Groundwater Application Review Summary Form

Application # G- 18754

To: Kristopher Byrd, Well Construction and Compliance Section Manager
From: Joel Jeffery, Well Construction Program Coordinator
Subject: Review of Water Right Application G-18754
Date: January 8, 2019

TO: Water Rights Section Date 12/28/2018
 FROM: Groundwater Section Aurora C Bouchier
 Reviewer's Name
 SUBJECT: Application G- 18754 Supersedes review of na
 Date of Review(s)

Cross Section/Profile

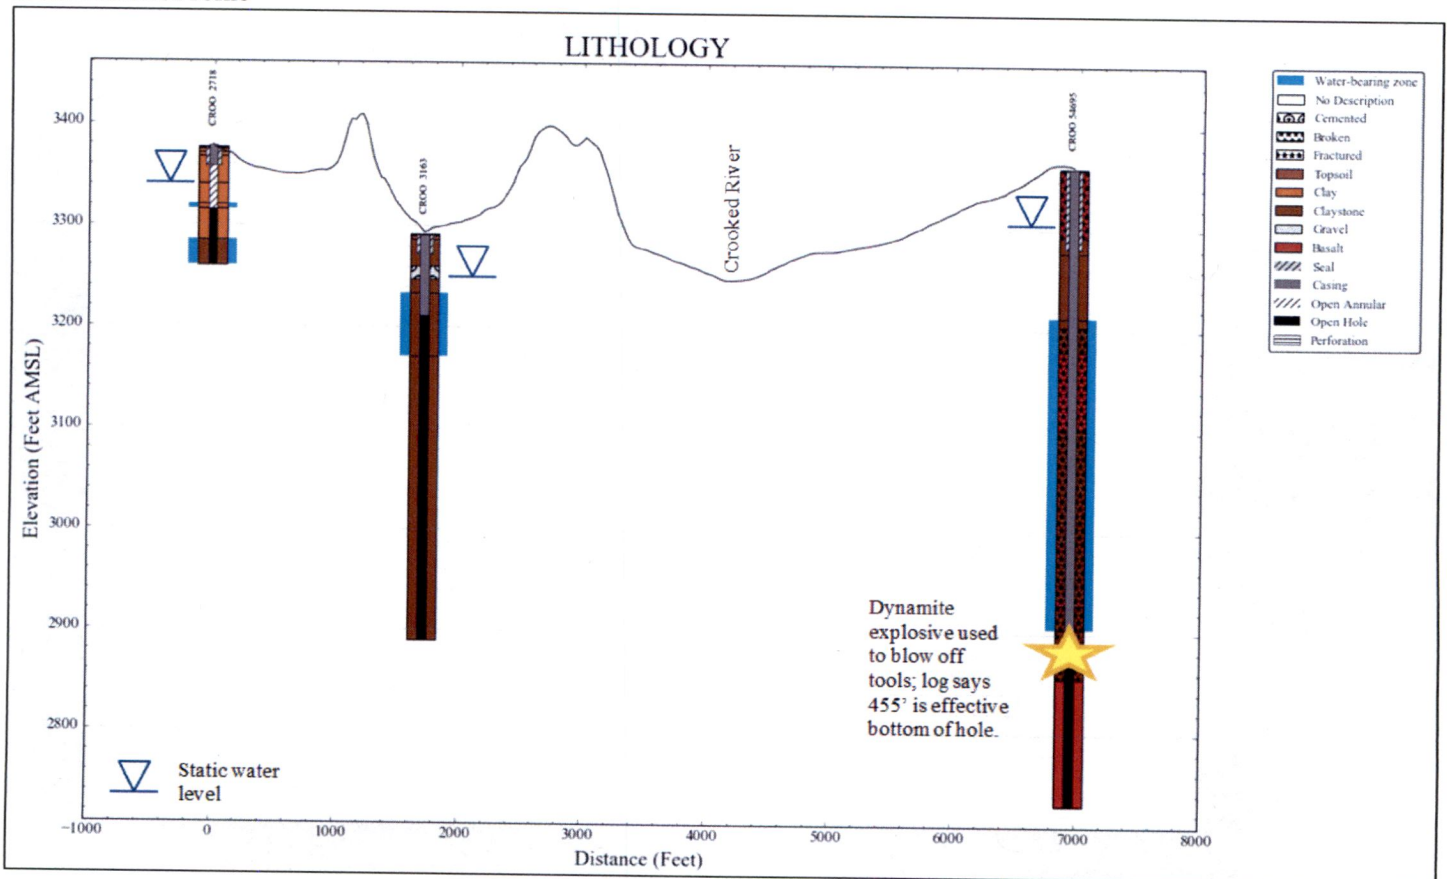
The Clarno rocks appear to be vertically fractured locally, and groundwater in the volcanic fractures may be hydraulically connected to the overlying sediments, when saturated, and subsequently to surface water (see the log for CROO 54695).

Basis for aquifer hydraulic connection evaluation: The elevation of the hydraulic head in nearby wells is coincident with or above the surface water elevation. However, the existing nearby wells all have well seal depths MUCH less than 400 feet. The well log for nearby test well (CROO 54695) indicates a water bearing zone from 147 to 455 feet below land surface in a series of fractured basalt and fractured claystone layers. Based on the well log, no additional water was found from 455 to 630 feet. The hydraulic head in CROO 54695 is above the surface water elevation. The Crooked River likely represents a regional hydrologic sink.

****There are no wells with construction similar to what is proposed on the application or stipulated in section 3B. If water is found at depth it will likely be confined, but the hydraulic head is unknown.** It is possible that the head in the proposed wells will be similar to that in CROO 54695, and it is also possible that no/minimal water will be found at depth. The fractured nature of the Clarno formation likely results in a hydraulic connection between the aquifer at depth and the Crooked River – although it is likely it is an inefficient connection. The special permit conditions requiring continuous casing and continuous seal from land surface to a depth of 400 feet should attenuate any hydraulic connection.

Special Condition: the wells must be continuously cased and continuously sealed from land surface to a depth of 400 feet below land surface.
